Access Compliance Report

Public Rights-of-Way

(Curb Ramps)

Intersection ID: 21132	Main Street: W_ARROWOOD_RD	Cross Street: SOUTHERN_PINE_BV	Location: SW
ADA ID: EE6683CF8D7D	Ramp Type: Perp	Initial Pass/Fail: Fail	Overall Compliance: No
Severity Score: 22.5			
Codes/Mitigation Info/Possible Solution		Field Measurements/Component Compliance

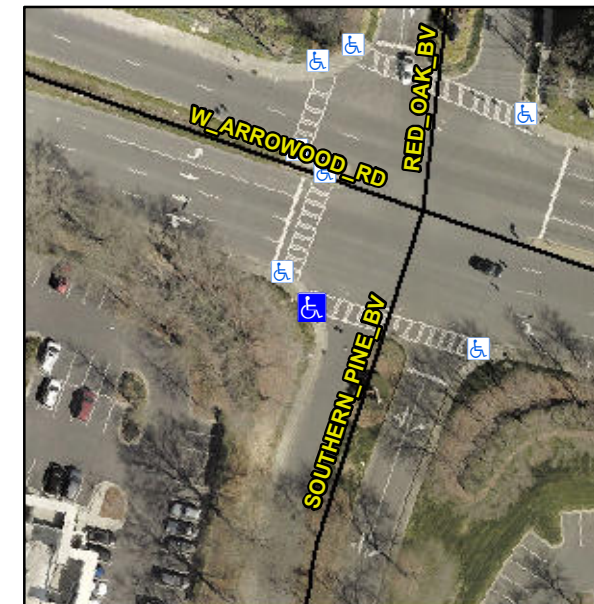
Not Found, R304.5.1, R304.2.2, R304.5.3

Compliance	Description	Data	Compliance	Description	Data
N/A	Ramp Length (in)	72.0	No	Ramp Slope (%)	9.2
No	Ramp Width (in)	43.0	No	Ramp XSlope (%)	4.5
N/A	Flare Type LT	N/A	N/A	Flare Type RT	N/A
N/A	Flare Slope LT (%)	N/A	N/A	Flare Slope RT (%)	N/A
N/A	Flare Traversable LT?	N/A	N/A	Flare Traversable RT?	N/A
N/A	Landing Length (in)	N/A	N/A	DWS Provided?	N/A
N/A	Landing Width (in)	N/A	N/A	DWS Contrast?	N/A
N/A	Landing Slope (%)	N/A	N/A	DWS Length (in)	N/A
N/A	Landing X Slope (%)	N/A	N/A	DWS Full Width?	N/A
N/A	Landing Curb? (Y/N)	N/A	N/A	DWS Offset (in)	N/A
N/A	Shared Landing?	N/A			
N/A	Gutter Ponding?	N/A	N/A	Gutter Slope (%)	N/A
N/A	Gutter Lip Ht (in)	N/A	N/A	Gutter X Slope (%)	N/A
N/A	Painted X Walk1?	Yes	N/A	Painted X Walk2?	N/A
	X Walk 1 Direction	To SE		X Walk 2 Direction	N/A
N/A	X Walk 1 Width (in)	111.0	N/A	X Walk 2 Width (in)	N/A
	X Walk 1 Slope (%)	3.5		X Walk 2 Slope (%)	N/A
	X Walk 1 X Slope (%)	2.2		X Walk 2 X Slope (%)	N/A

Remove & Replace Entire Ramp.
